**Addendum u to
ASHRAE Guideline 36-2018**

Proposed Addendum u to Guideline 36-2018, High-Performance Sequences of Operation for HVAC Systems

**First Public Review (November 2020)
(Draft shows Proposed Changes to Current Guideline)**

This addendum includes edits to the automatic fault detection and diagnostics sections. AHU operating state tables and figures for return fan systems, which were previously missing, have been added. Fault Condition #1 has been updated to use DSPavg instead of DSP for consistency. A directive has been added to delete Fault Condition #7 if there is no heating coil. Fault Condition #12 has been expanded to include operating state, OS#2, as supply air temperature should be less than or equal to mixed air temperatures when in economizer.

Figure 5.16.14.2 VAV AHU operating states.

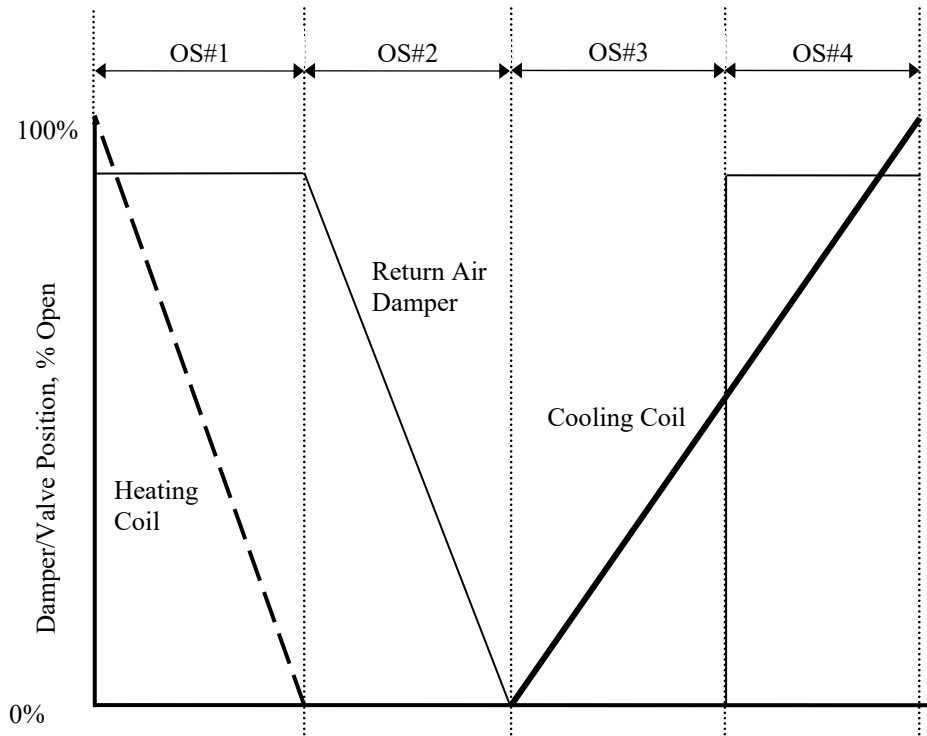
5.16.14.2 For units with return fans:

- a. The OS of each AHU shall be defined by the commanded positions of the heating coil control valve, cooling coil control valve, and return air damper in accordance with Table 5.16.14.2

Figure 5.16.14.3 VAV AHU operating states.

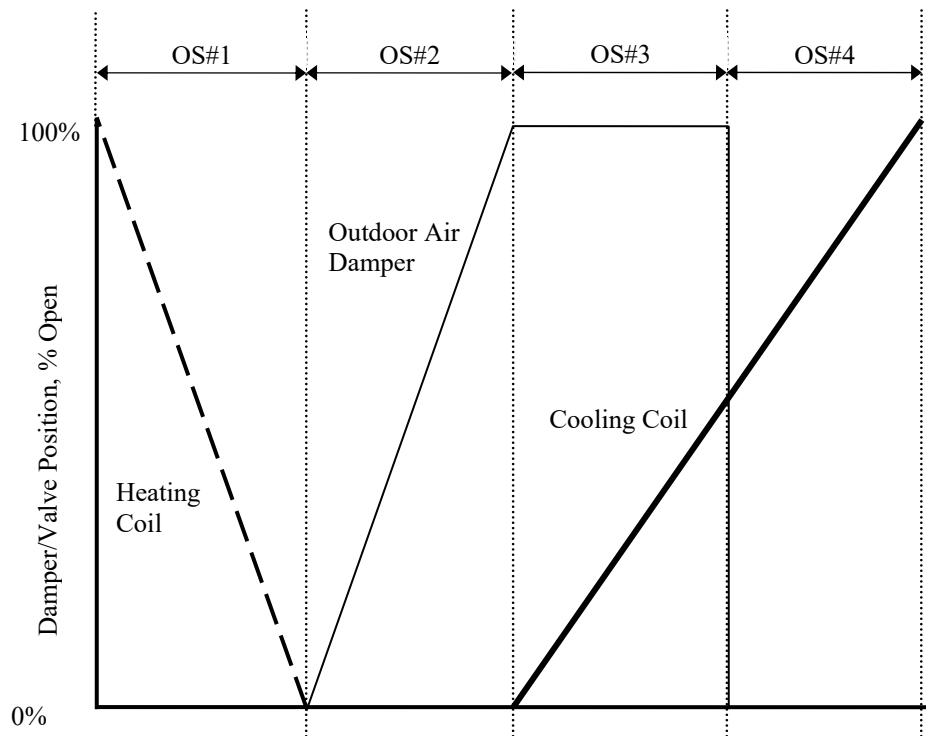
5.16.14.3 For units with relief dampers or relief fans and a separate minimum outdoor air damper:

- a. The OS of each AHU shall be defined by the commanded positions of the heating-coil control valve, cooling-coil control valve, and economizer damper in accordance with Table 5.16.14.3 and Figure 5.16.14.3.

Figure 5.16.14.2-4 VAV AHU operating states.

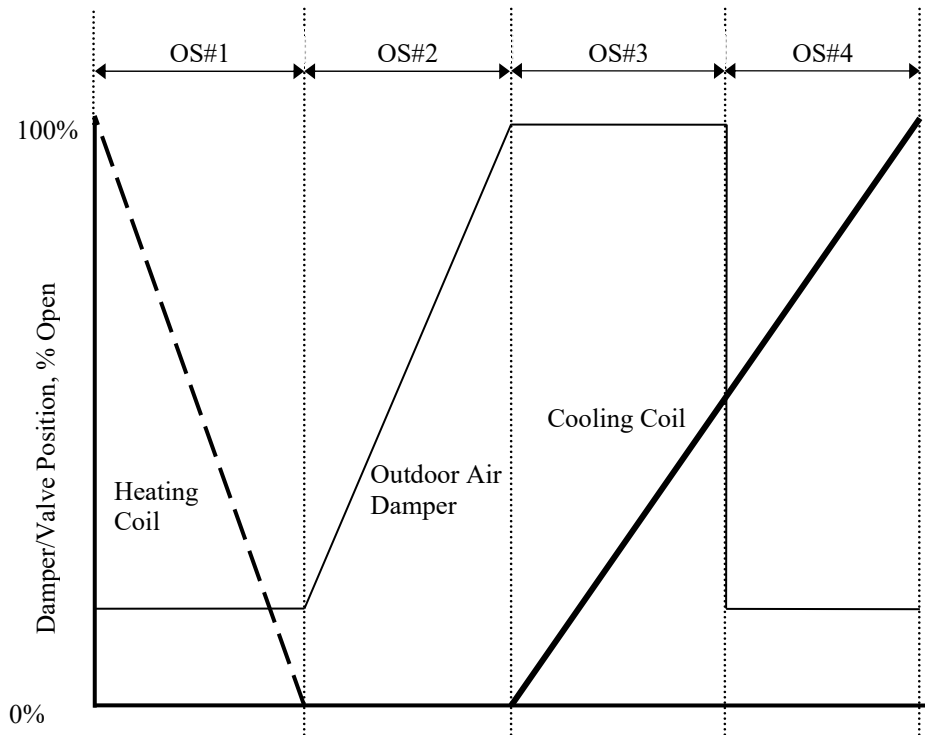
5.16.14.4 For units with relief dampers or relief fans and a single common damper for minimum outdoor air and economizer functions:

- a. The OS of each AHU shall be defined by the commanded positions of the heating-coil control valve, cooling-coil control valve, and economizer damper in accordance with Table 5.16.14.24 and Figure 5.16.14.24.

Figure 5.18.13.14.2 SZVAV AHU operating states.

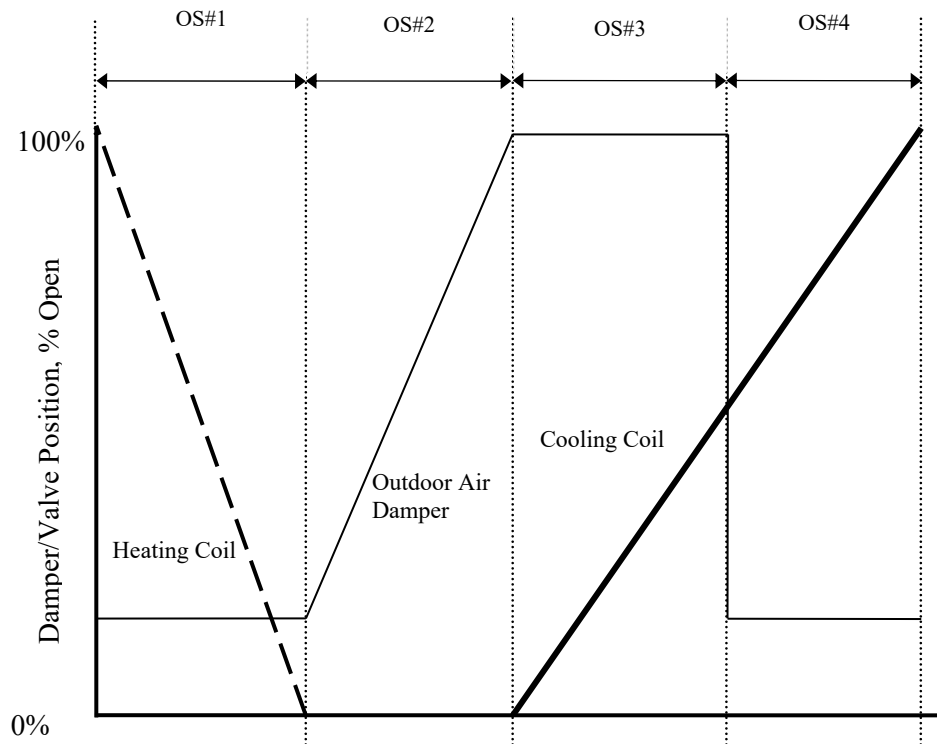
5.18.14.2 The OS of each AHU shall be defined by the commanded positions of the heating-coil control valve, cooling-coil control valve, and economizer damper in accordance with Table 5.18.14.2 and Figure 5.18.14.2.
